Product Change Notification: BLAS-20WDYJ907

CCB 8229 Final Notice: Implement new carrier tape and cover tape design for AT32UC3A0512-ALUR and AT32UC3A0512-ALUT catalog part numbers (CPN) available in 144L LQFP (20x20x1.4mm) package at ANAP assembly site.

CCB 8229
Pre and Post Change Summary
PCN #: BLAS-20WDYJ907

Pre and Post Change Summary – Carrier Tape

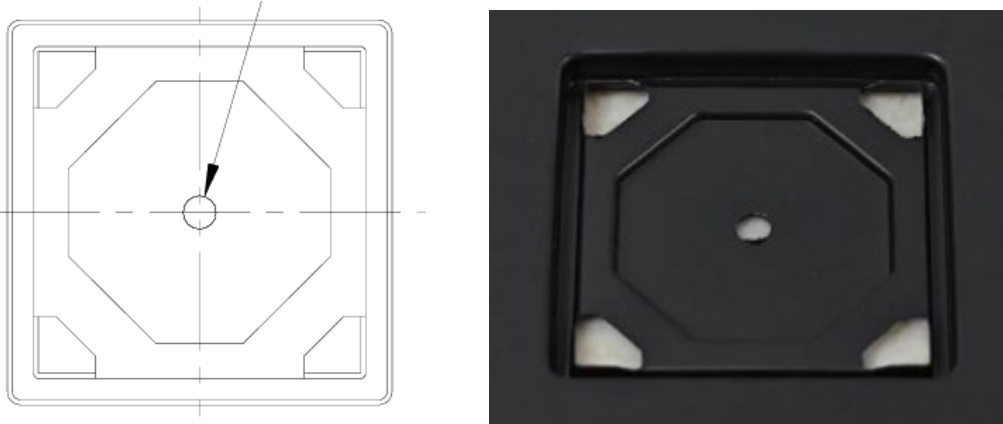
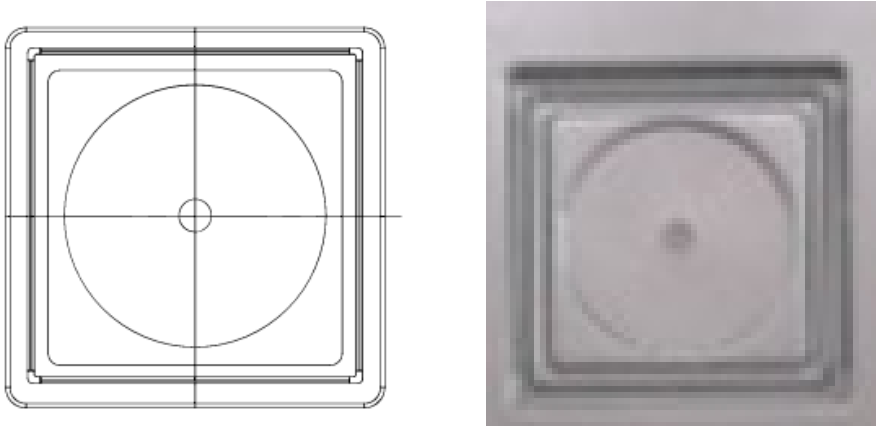
Plant	Ao	Bo	Ko	K1	Tape Pitch	Tape Width	K2	Length
ANAP (Pre Change)	22.63 ± 0.10 mm	22.63 ± 0.10 mm	2.15 ± 0.10 mm	1.42 ± 0.10 mm	32.00 ± 0.10 mm	44.00 ± 0.30 mm	N/A	99m
ANAP (Post Change)	22.70 ± 0.10 mm	22.70 ± 0.10 mm	2.10 ± 0.10 mm	1.60 ± 0.10 mm	0.90 ± 0.10 mm	32.00 ± 0.10 mm	0.90 ± 0.10 mm	89m
